DEVELOPMENT REVIEW

Project description Applicant is proposing two commercial buildings totaling 88,748 sf of office / flex space and a 33,190 sf building for RV storage with associated site improvements.

**Re: 2564 S. Kings Highway – Development & Design Review
TRC Response to Comments
TRC Project # 20-07000002**

On behalf of our client, please find the attached response to comments received on March 18, 2021 for a project known as Walsh Kings Highway. Each comment is identified below followed by a response in ***bold italics***.

WEST ELEVATION BUILDINGS 1 AND 2 SCALE 1/4" = 1'-0"

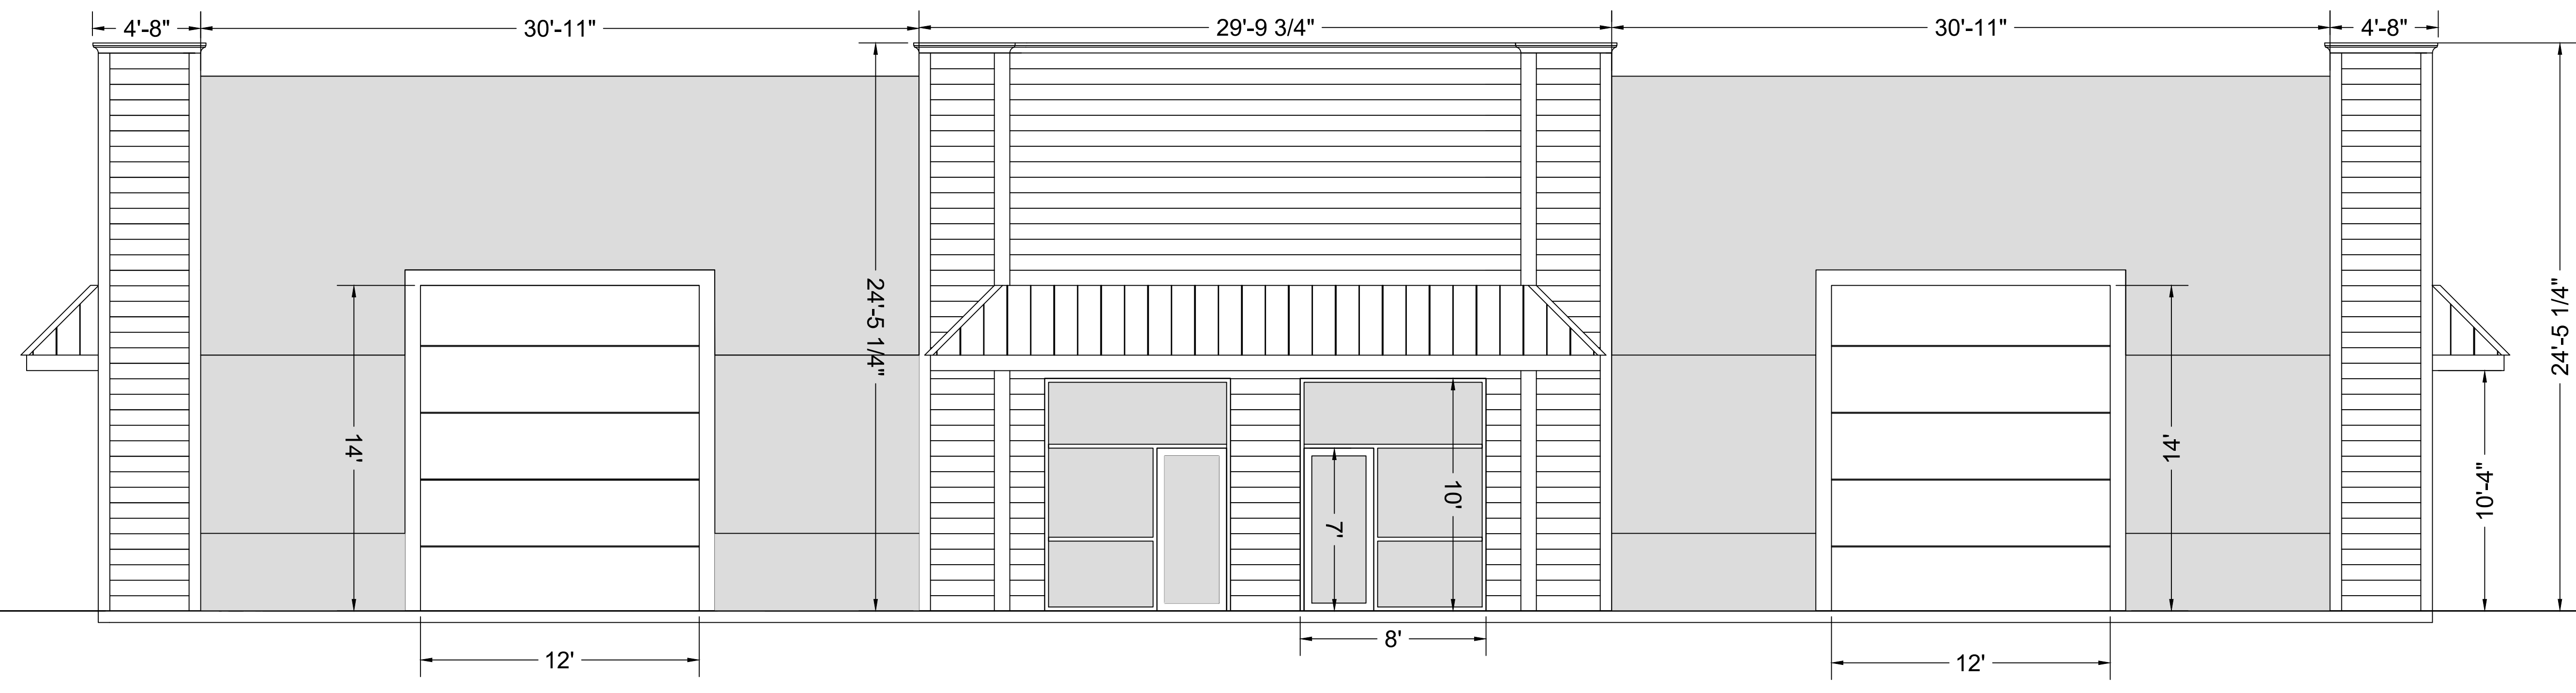
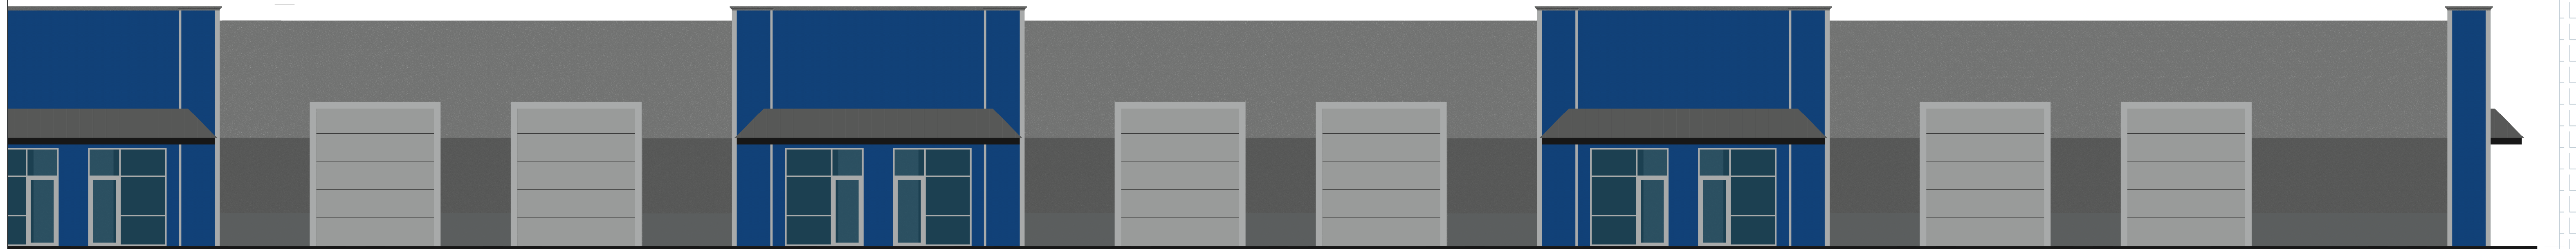
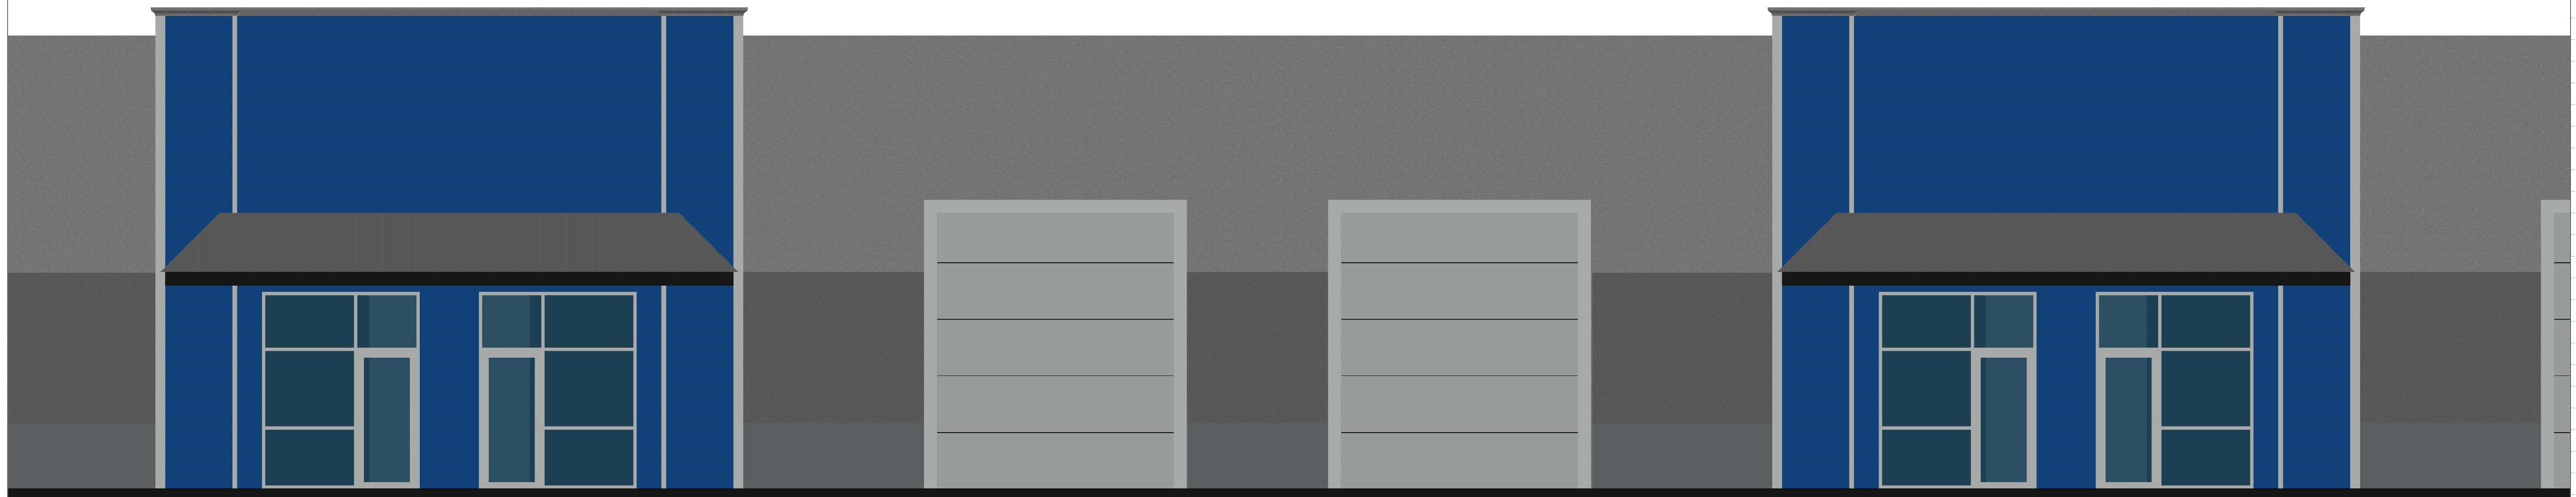
- Some sort of Stonework should be added to the outside building design to further enhance the look of the building. Larger windows are suggested.
- Up-lighting should be incorporated to the outside of the building to enhance the building in the evening hours.
- Provide a materials board.

RESPONSE: *This project is located along an industrial corridor and has a side elevation fronting on Kings Highway and is located away from true commercial general uses. The architectural style of the property is consistent with the newer flex-space uses being constructed in the Treasure Coast. The architectural style in addition to the proposed landscaping will be a positive addition to the area. Included with this resubmittal, please find additional elevations and plan views for review.*
